Product Change Notification

PCN-ICC-3267-2019

Business Unit	Product Line Code	Type of Change	Action	Date of Issue
ICC - Industrial Cabinet	BE2	Product Change Notification	Notify Distributors and Field	2/18/2019

Description for Product Change Notification

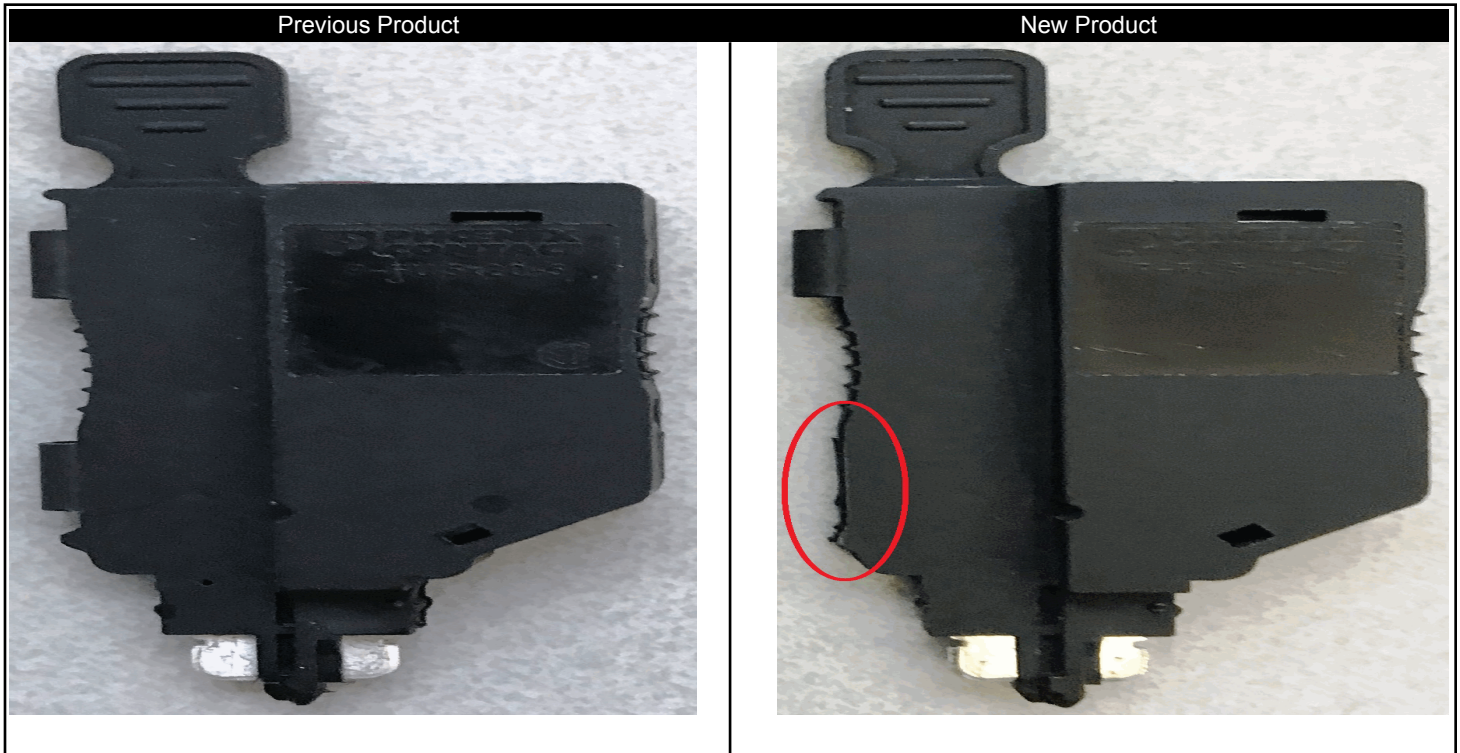
To improve the access to the screw terminal on certain types of terminal blocks, the lower hinge is being removed on the P-FU plug.
